DEVIATION REQUEST AND DECISION FORM

Project Name : CLOVERLEAF SUBDIVISION
 Schedule No.(s) : 7124202236, 7124202237, 7123102041, 7123102044
 Legal Description : SEE ATTACHED – Exhibit B

CLOVERLEAF ROAD AND CRIMSON CLOVER LANE PLAN & PROFILE

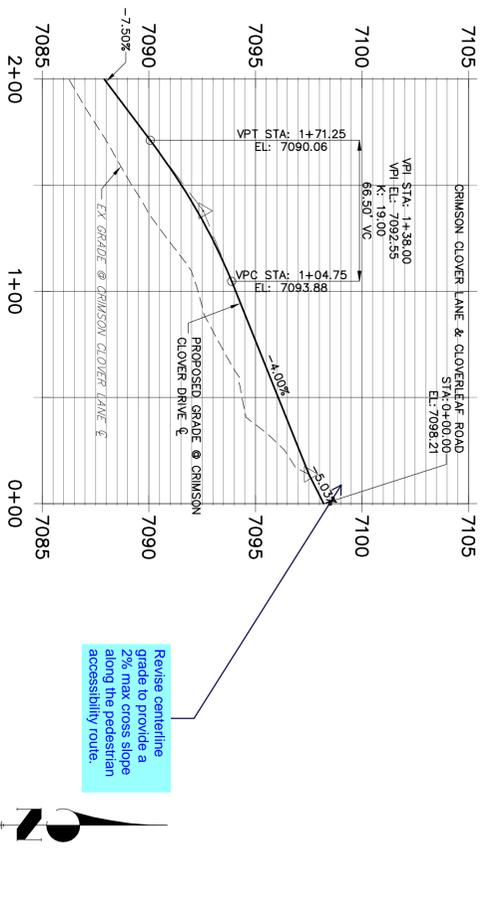
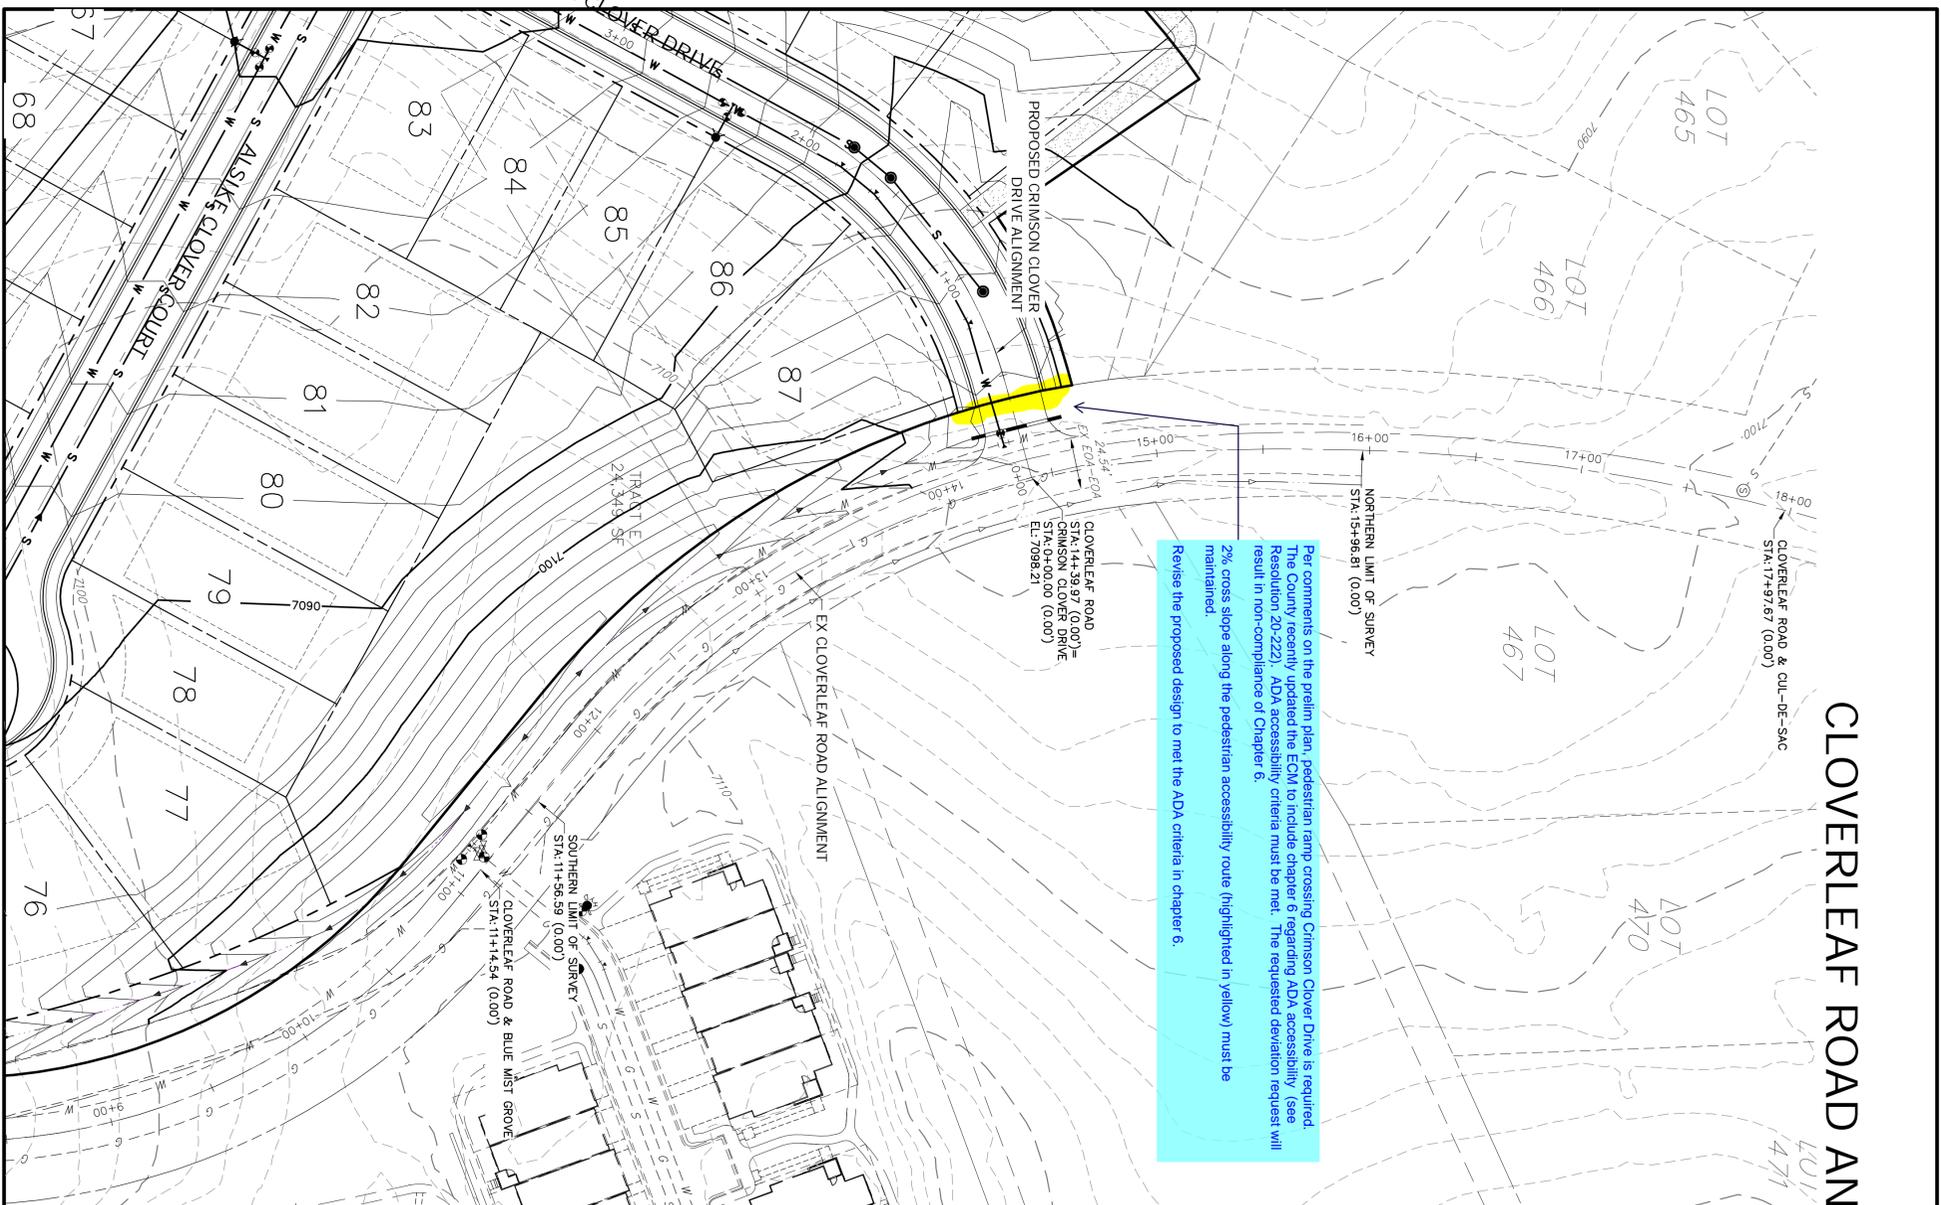
Show the sight distance on the plan and profile.
See ECM table 2-18 for SSD at grade.

Per comments on the prelim plan, pedestrian ramp crossing Crimson Clover Drive is required. The County recently updated the ECM to include chapter 6 regarding ADA accessibility (see Resolution 20-222). ADA accessibility criteria must be met. The requested deviation request will result in non-compliance of Chapter 6.

2% cross slope along the pedestrian accessibility route (highlighted in yellow) must be maintained.

Revise the proposed design to meet the ADA criteria in chapter 6.

Revise centerline grade to provide a 2% max cross slope along the pedestrian accessibility route.
